Access Compliance Report

Public Rights-of-Way

Intersection ID: 17337	Main Street: PROVIDENCE_DR	Cross Street: VERNON_DR	Location: SE
ADA ID: 4F3CEF3C3E76	Ramp Type: PerpDiag	Initial Pass/Fail: Fail	Overall Compliance: No
Codes/Mitigation Info/Possible Solution		Field Measurements/Component Compliance	
Severity Score: 46.25

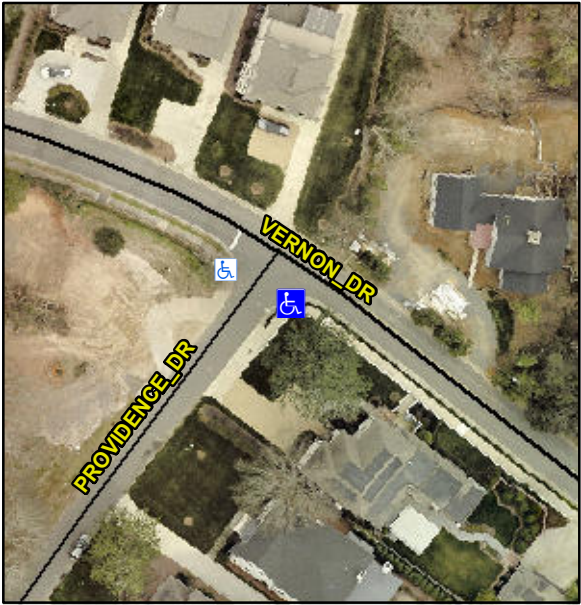
Possible Solutions:		Compliance	Description	Data	Compliance	Description	Data
	Remove & Replace Curb Ramp With Two New Directional Ramps or Equivalent.		N/A	Ramp Length (in)	82.0	No	Ramp Slope (%)	8.5
<p>Surveyor Notes:</p> <p>N/A</p> <p>PROW/ADA:</p> <p>Not Found, R304.5.1, R304.2.2, R304.5.3</p>			No	Ramp Width (in)	47.0	No	Ramp XSlope (%)	14.9
			N/A	Flare Type LT	N/A	N/A	Flare Type RT	N/A
			N/A	Flare Slope LT (%)	N/A	N/A	Flare Slope RT (%)	N/A
			N/A	Flare Traversable LT?	N/A	N/A	Flare Traversable RT?	N/A
			N/A	Landing Length (in)	N/A	N/A	DWS Provided?	N/A
			N/A	Landing Width (in)	N/A	N/A	DWS Contrast?	N/A
			N/A	Landing Slope (%)	N/A	N/A	DWS Length (in)	N/A
			N/A	Landing X Slope (%)	N/A	N/A	DWS Full Width?	N/A
			N/A	Landing Curb? (Y/N)	N/A	N/A	DWS Offset (in)	N/A
			N/A	Shared Landing?	N/A			
			N/A	Gutter Ponding?	N/A	N/A	Gutter Slope (%)	N/A
			N/A	Gutter Lip Ht (in)	N/A	N/A	Gutter X Slope (%)	N/A

N/A	Painted X Walk1?	No	N/A	Painted X Walk2?	No
				X Walk 1 Direction	To NE		X Walk 2 Direction	To NW
			N/A	X Walk 1 Width (in)	N/A	N/A	X Walk 2 Width (in)	N/A
				X Walk 1 Slope (%)	10.5		X Walk 2 Slope (%)	1.7
				X Walk 1 X Slope (%)	0.1		X Walk 2 X Slope (%)	8.9
			N/A	Ramp inside XWalk1?	N/A	N/A	Ramp inside XWalk2?	N/A
				Road Slope (%)	6.6	N/A	Clear Space?	N/A
				Road X Slope (%)	5.6	N/A	Clear Space to XWalk (in)	N/A
			N/A	Any Obstructions?	N/A	N/A	Storm Grate/Utility Hazard?	N/A
				Obstruction Type			Storm Grate/Utility Type	
						N/A		N/A
						Yes	Surface Condition? (G/P)	Good
